Urgent Field Safety Notice

GE Ref: FMI 12150

RE: **Innova® 2000 cardiovascular X-ray imaging systems: Source to Image Distance (SID) failure.**

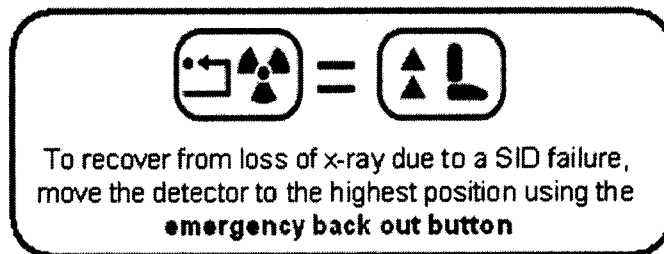
As described in the Operator Manual delivered with the Innova 2000 system, one of the emergency back-out buttons should be used to bring the digital detector to the highest position to recover X-Ray in the event of SID failure. There are three emergency back-out buttons available on Innova 2000 systems (one on the left, one on the front, and one on the right side of the detector). This button is the purple button as shown below.

**message error display is mentioning orange button but in fact this button is purple as shown in the photo below*

Product Correction GE Healthcare will affix the label shown below on the detector to remind operators how to recover from loss of X-ray due to SID failure. A GE Healthcare service representative will contact you to arrange for this correction. This activity will be performed at no cost to you.
